STERLING RANCH PHASE 2 PRELIMINARY PLAN

VISUAL ANALYSIS

AUGUST, 2018

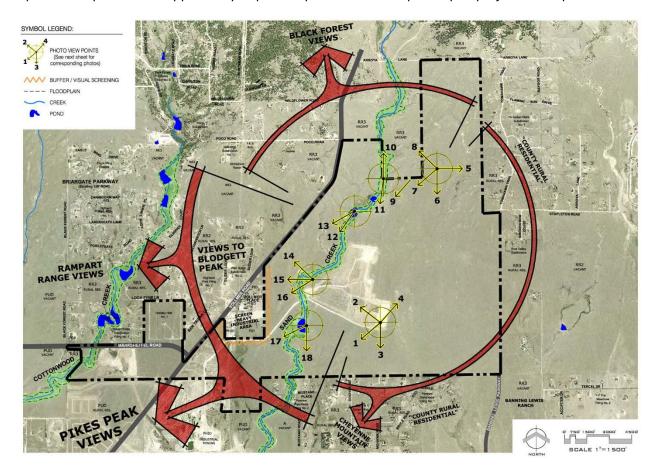
which view point is within this prelim boundary....Considering the requirement for buffer to the south you should at least have that perspective in here.
